Addendum No.: 4

Date of Addendum: May 4, 2020

Prudence Crandall Museum Renovations  
1 South Canterbury Road  
Canterbury, CT  
BI – RR – 28

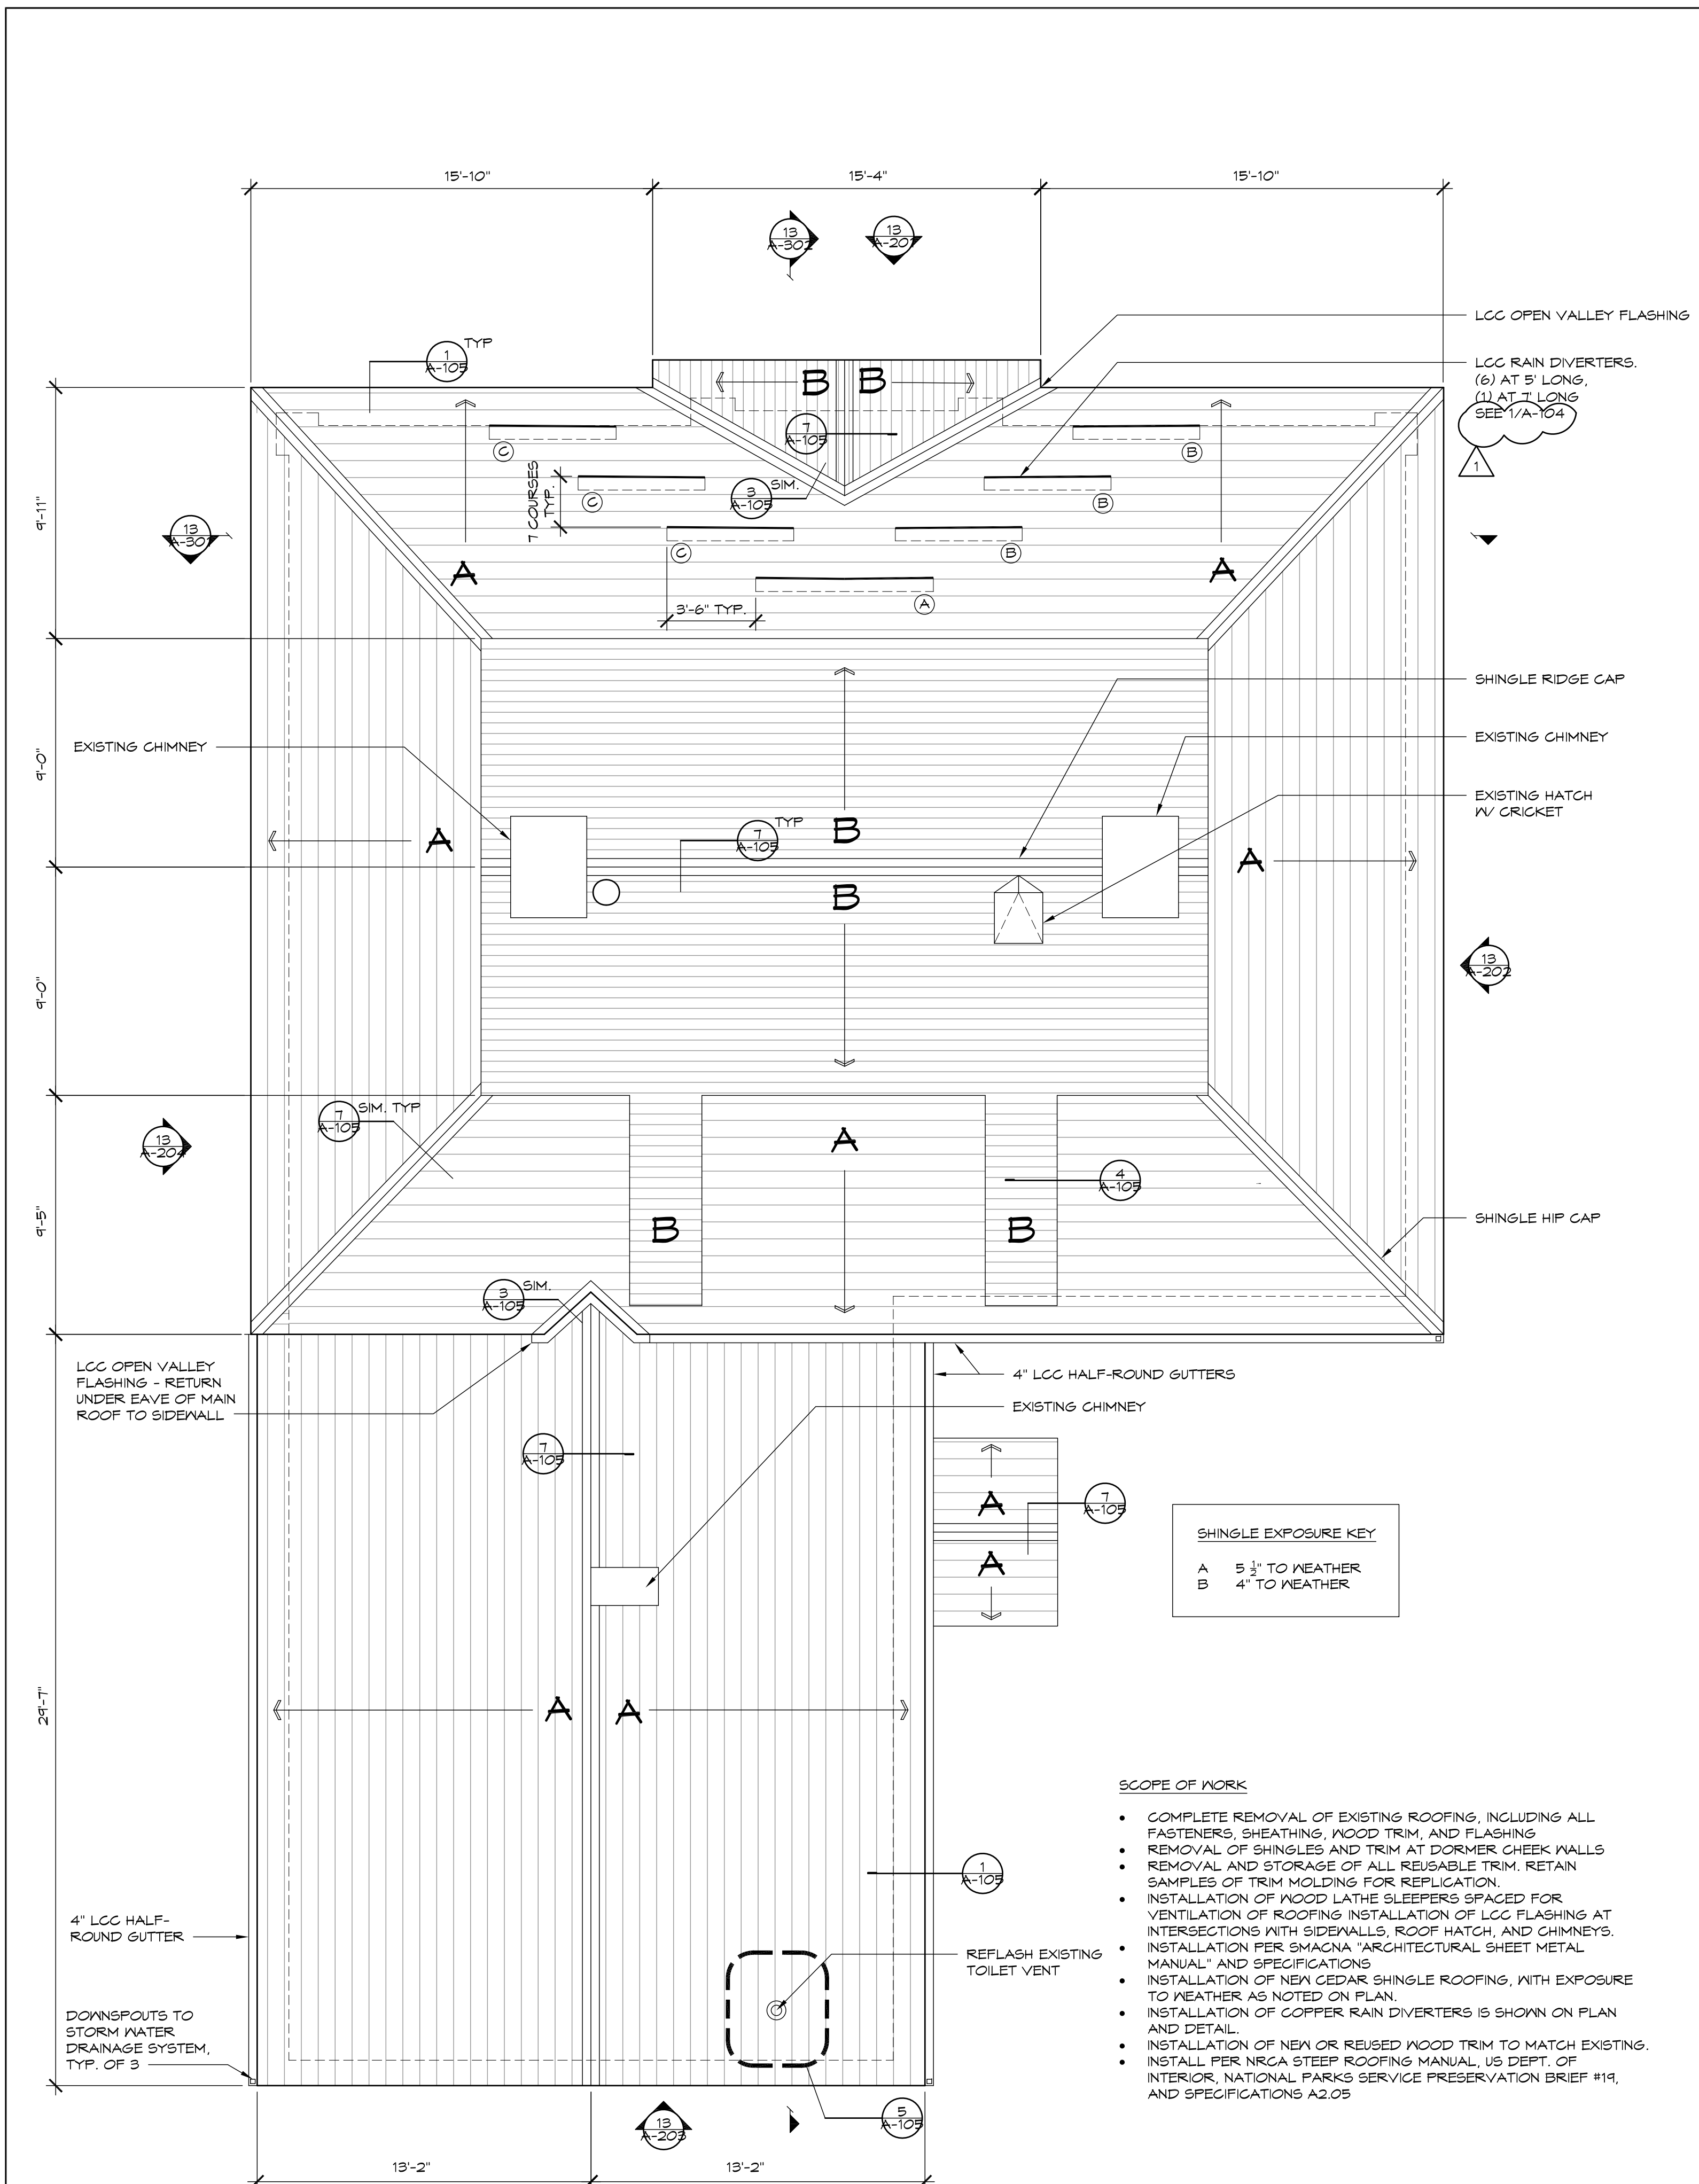
**Question 1:** *What is material thickness required for the LCC rain diverters?*

**RESPONSE:** Material thickness for LCC rain diverters to be a minimum of 16 oz. (24 gauge). See revised Architectural drawings A-104 and A-105, attached.
